PRELIMINARY DRAINAGE REPORT

WATERSIDE TOWNHOMES (Waterside Condominiums Subdivision)

JULY 2022

Add text:
PCD Filing No.: PUDSP229

WATERSIDE TOWNHOMES
 MONUMENT, CO
 FINAL DRAINAGE REPORT
 EXISTING CONDITIONS DRAINAGE MAP

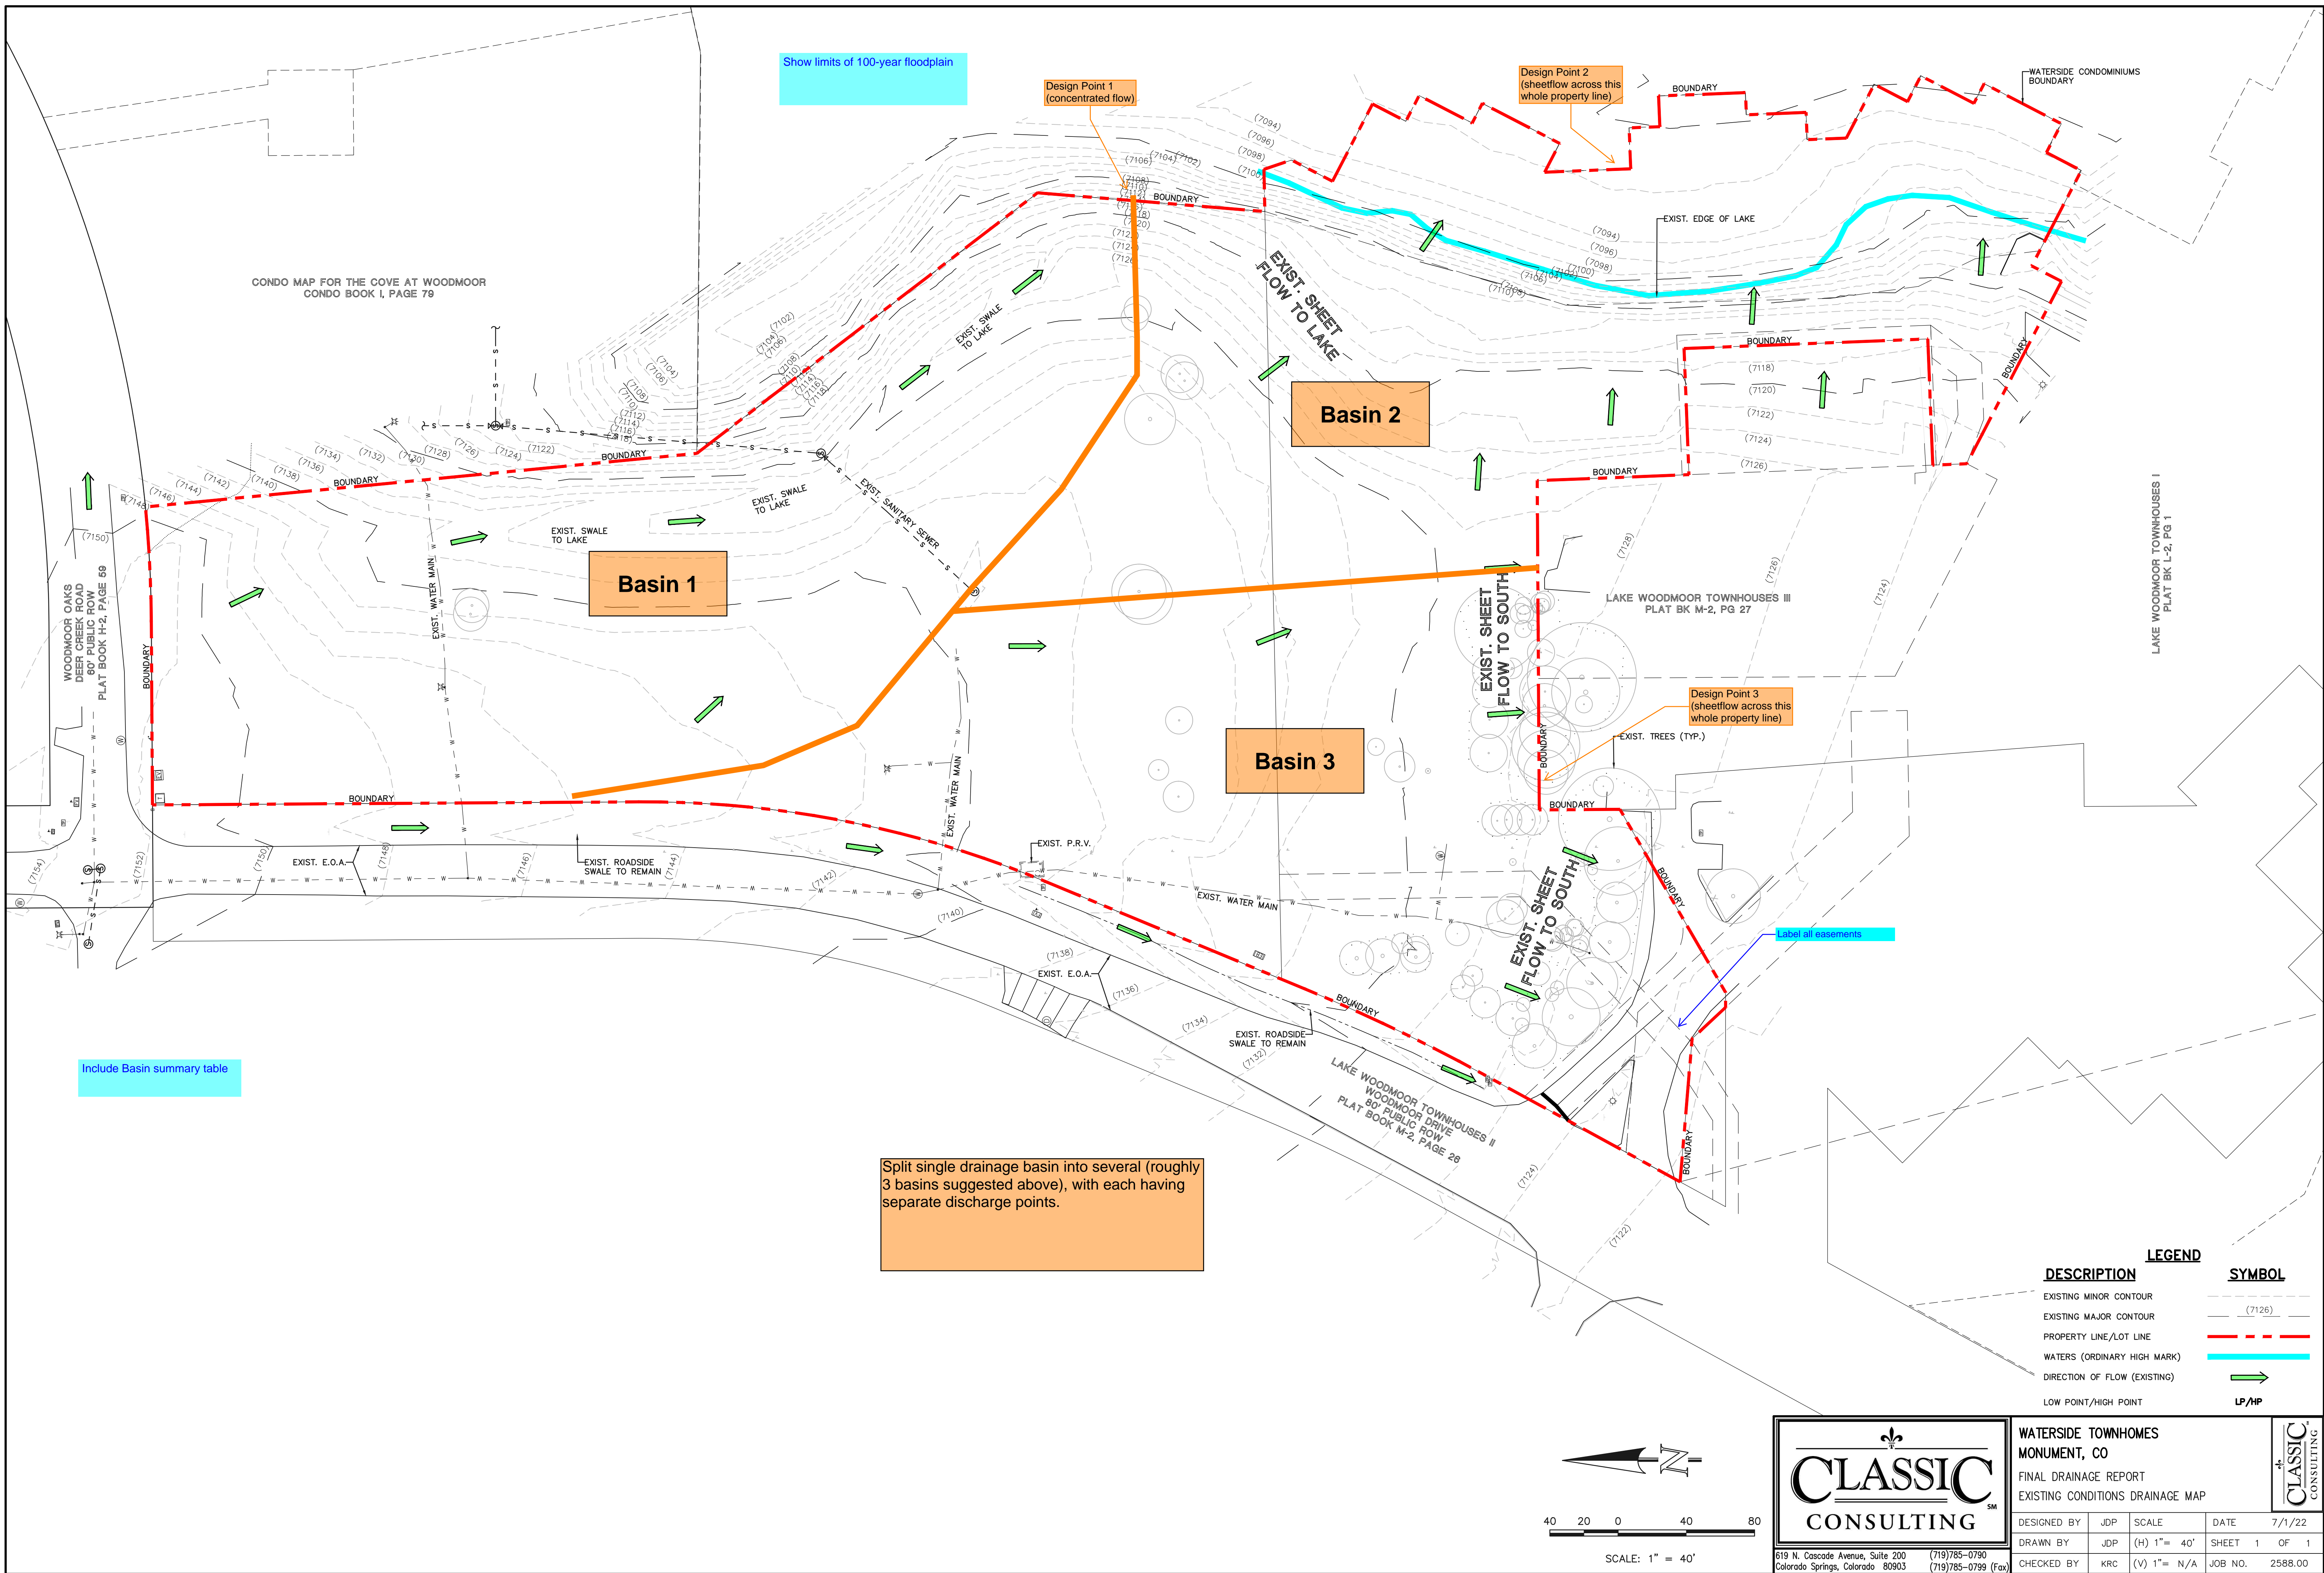
Show limits of 100-year floodplain

Design Point 1 (concentrated flow)

Design Point 2 (sheetflow across this whole property line)

Basin 1

Basin 2

Basin 3

Design Point 3 (sheetflow across this whole property line)

Label all easements

Split single drainage basin into several (roughly 3 basins suggested above), with each having separate discharge points.

Include Basin summary table

WATERSIDE TOWNHOMES
MONUMENT, CO
FINAL DRAINAGE REPORT
PROPOSED CONDITIONS DRAINAGE MAP

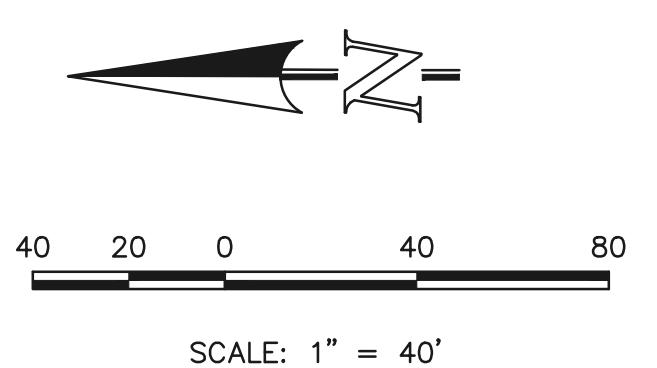
Split single drainage basin into several, with each having separate discharge points at each inlet. And the areas outside of the blue line (between the blue line and the red property line) should have their own basin(s) as well.

Show limits of floodplain

Need to provide access to pond

Show & label outlet structure & emergency overflow

Need to have a separate basin for rear lots which drain directly into lake and do not reach WQ pond

Add "WQ" to clarify that it will just be for WQ and not detention.

It appears that the "back yard" flow from this area is directed towards the WQ facility and will continue sheet flowing to the south.

Each inlet should have a corresponding design point. See ECM Section 3.2.8.G

What is this line? Label or remove

Include basin summary table
